Proposal for the 04 Series of Amendments to Regulation No. 100 (Electric power trained vehicles)

The text reproduced below was prepared by the expert from the Netherlands, aimed to an identification of buses and trucks equipped with an electric drivetrain which is consistent with existing regulated identification for Liquefied Petroleum Gas (LPG), Compressed Natural Gas (CNG), Liquid Natural Gas (LNG) and Compressed Hydrogen (H2) fuelled trucks and busses. The modifications to the existing text of the UN Regulation by document ECE/TRANS/WP.29/GRSP/2023/10 are marked in “bold black“ for new or strikethrough for deleted characters. The modifications made by this document are marked in “(bold) blue” for new or strikethrough for deleted characters.

Provisions for a Label for Vehicles of Categories M₂/N₂ and M₃/N₃ Equipped with an Electric Power Train

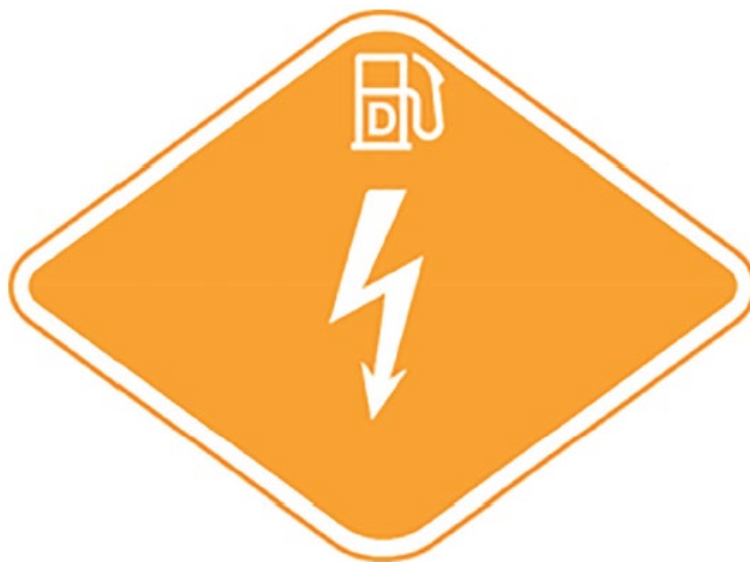
The label ~~consists of a sticker which~~ shall be weather resistant.

The centre zone indicates the first energy source.

The upper zone indicates the second energy source.

Layout and symbols shall be in accordance with ISO 17840-4:2018.

The colour and dimensions of the ~~sticker~~ label shall fulfil the following requirements:

Background:	Orange, RGB code 255, 165, 0
Border:	white or white reflecting
Letters:	white or white reflecting

Sticker width:	≥ 110 mm
Sticker height:	≥ 80 mm"
